ADDENDUM NO. 03 TO PROJECT NO. 47331

CONSTRUCTION WORK REHABILITATE THE EASTERN APPROACH STAIRCASE, PROMENADES, PORTICO, AND EXECUTIVE RAMP NEW YORK STATE CAPITOL ALBANY, NY

September 27, 2024

G003

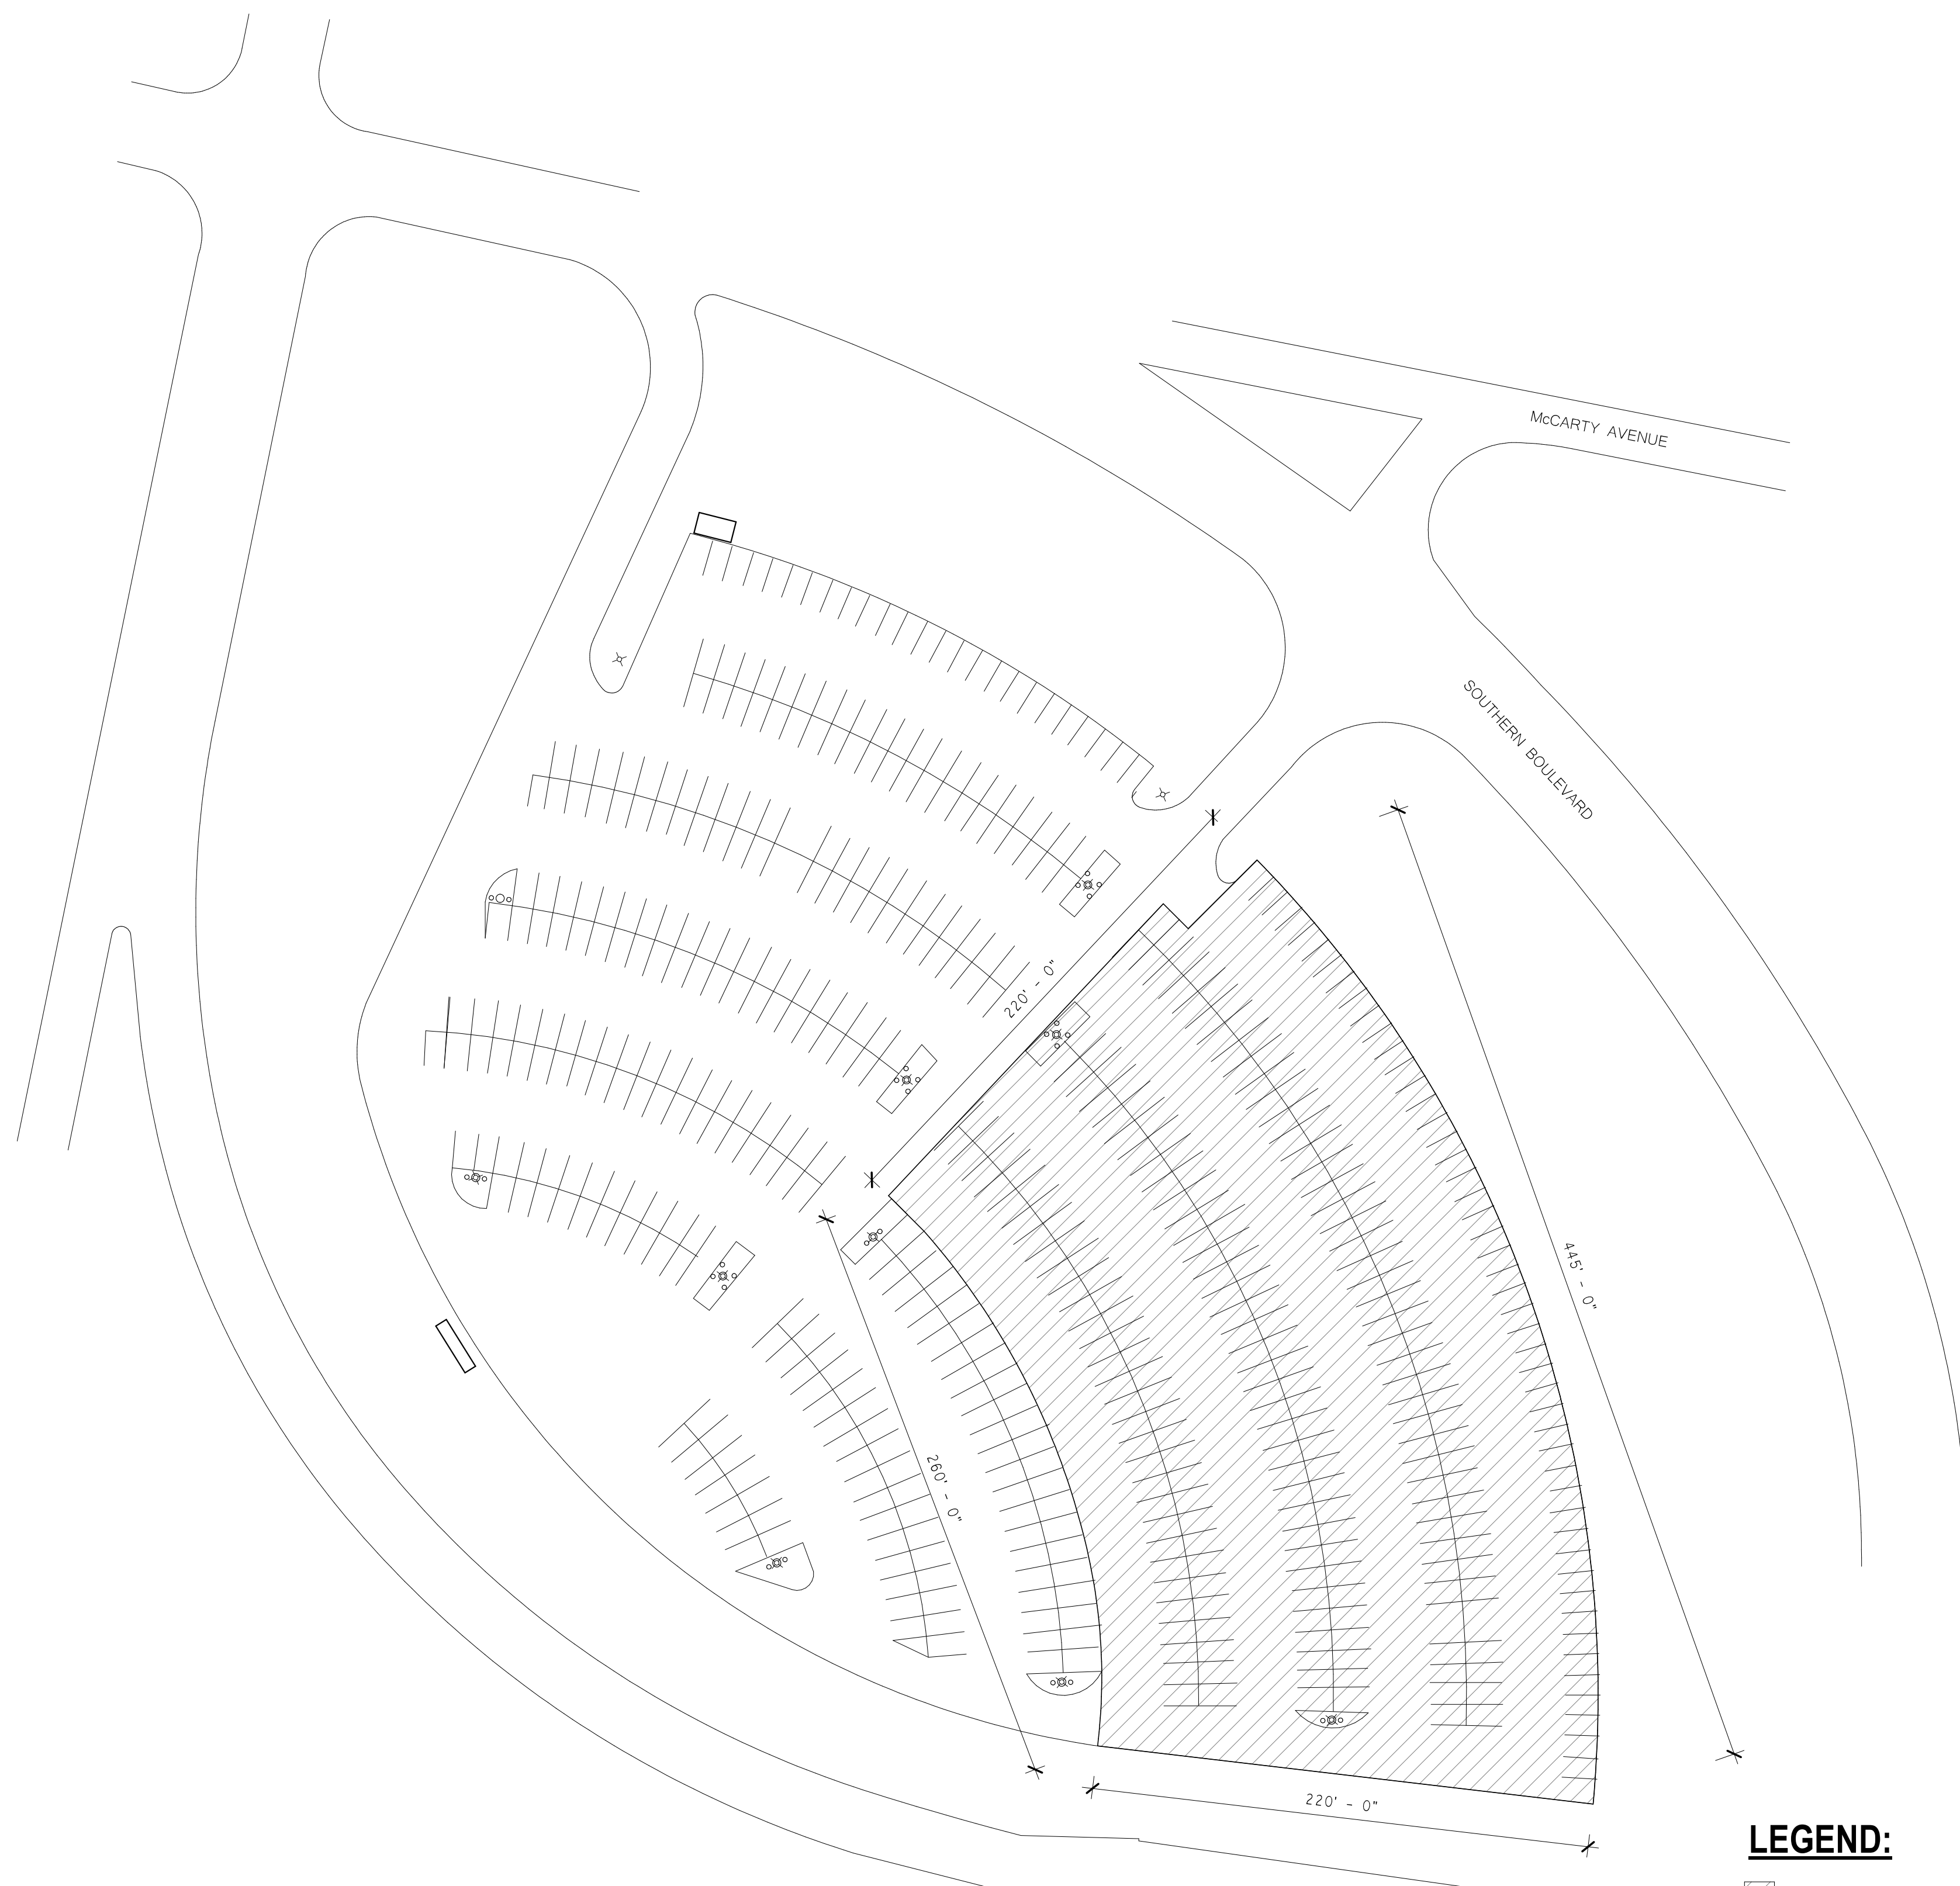
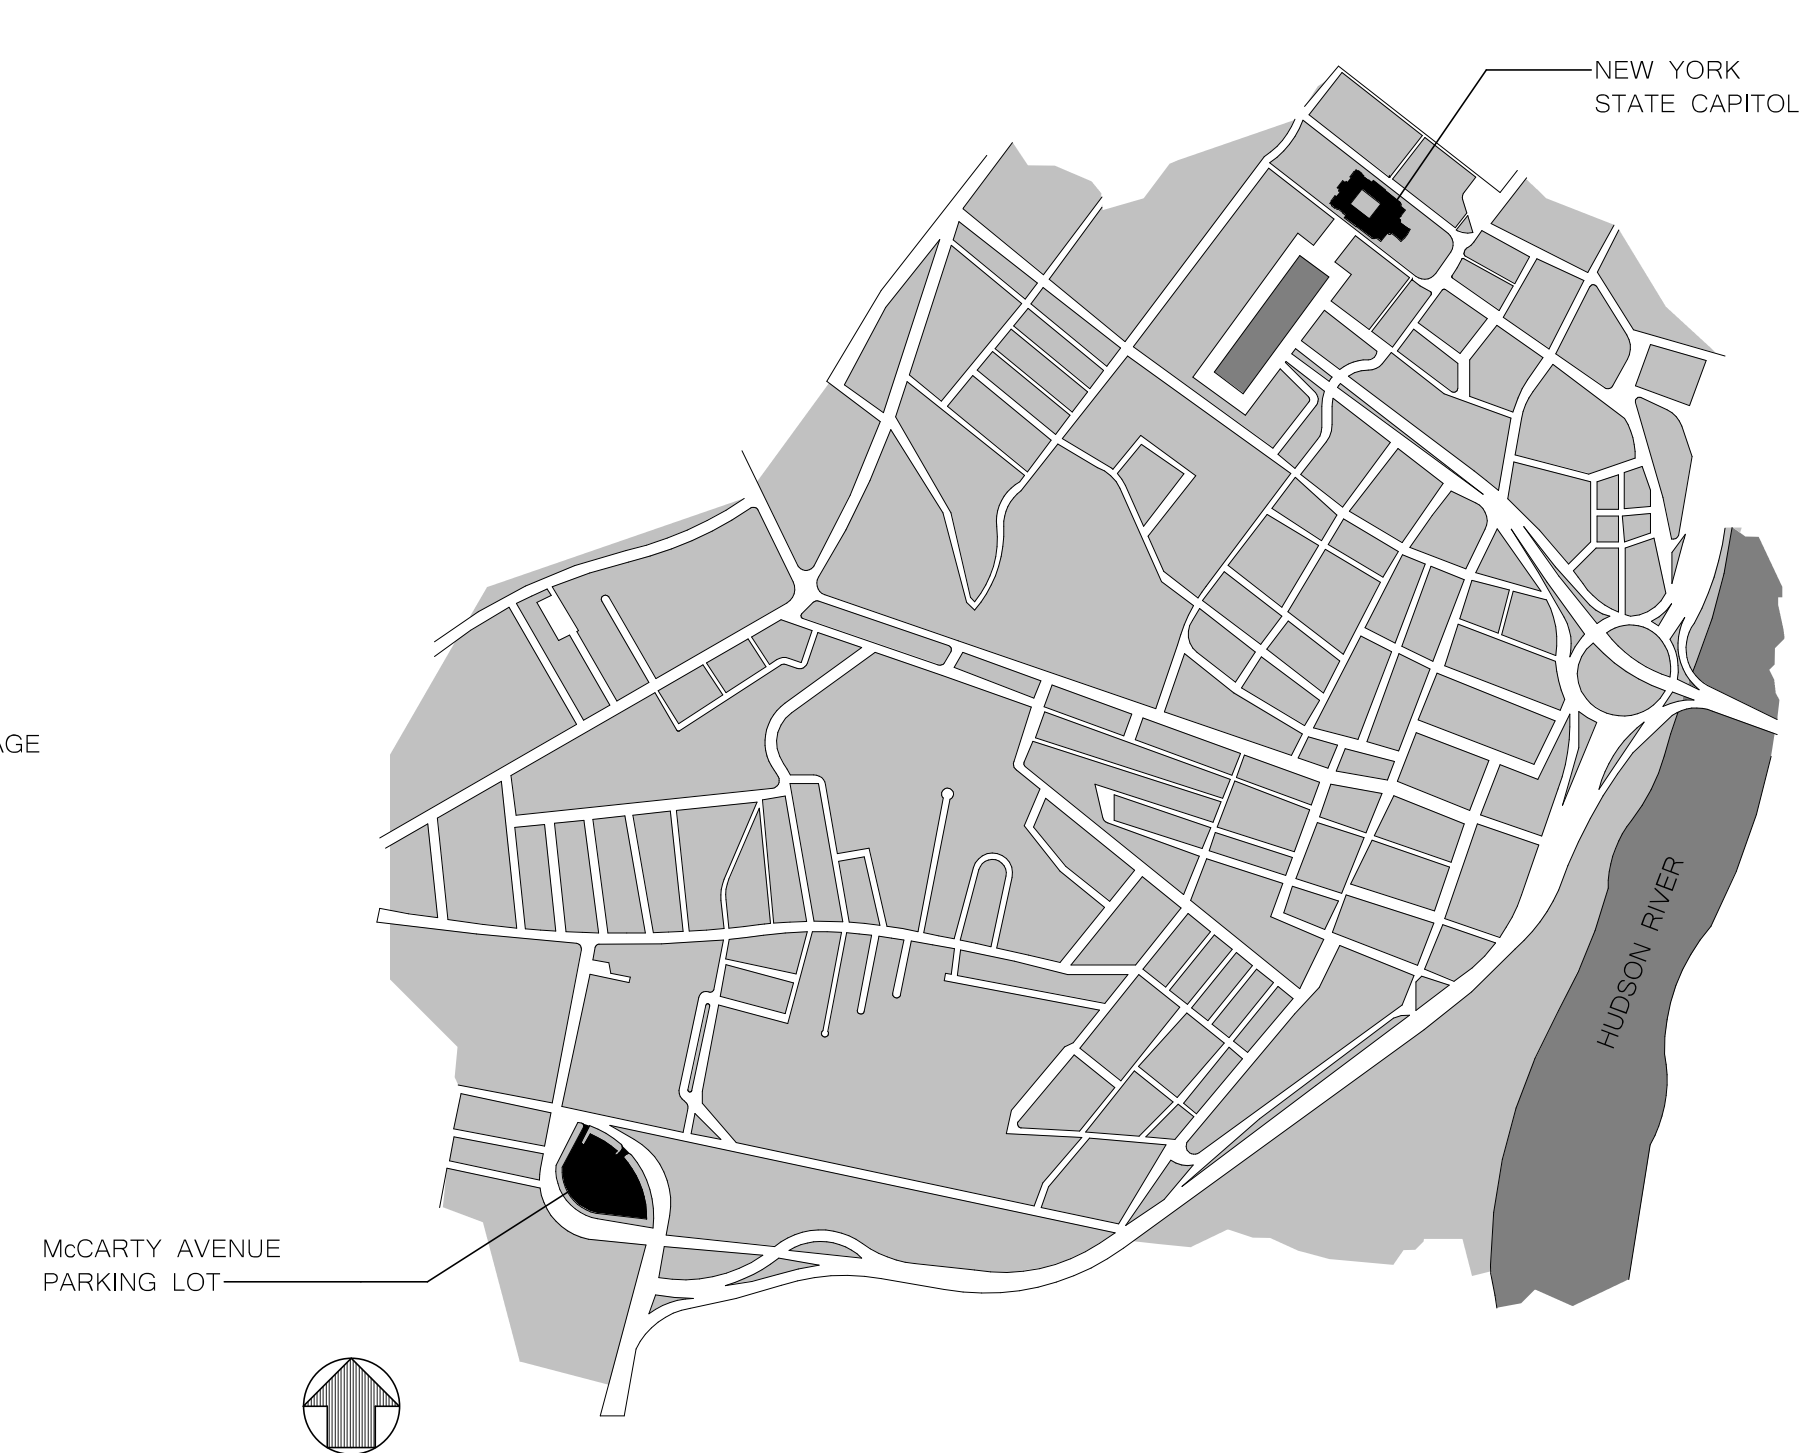
3. Revised Drawings:
 - a. Drawing Nos. R101.2 and G003, noted "REVISED 9/27/2024" accompany this Addendum and supersedes the same numbered originally issued drawings.

OFF-SITE STORAGE:
1. McCARTY AVENUE PARKING LOT IS AVAILABLE FOR OFF-SITE LONG-TERM STONE STORAGE. CONTRACTOR RESPONSIBLE FOR PROVIDING SECURITY FENCE, GATES, TEMPORARY LIGHTING, AND OTHER SECURITY MEASURES. USE OF PARKING LOT IS NOT REQUIRED. ALTERNATE SECURED LOCATION TO BE SUBMITTED FOR APPROVAL BY DIRECTOR'S REPRESENTATIVE. DISCUSS WITH DIRECTOR'S REPRESENTATIVE.
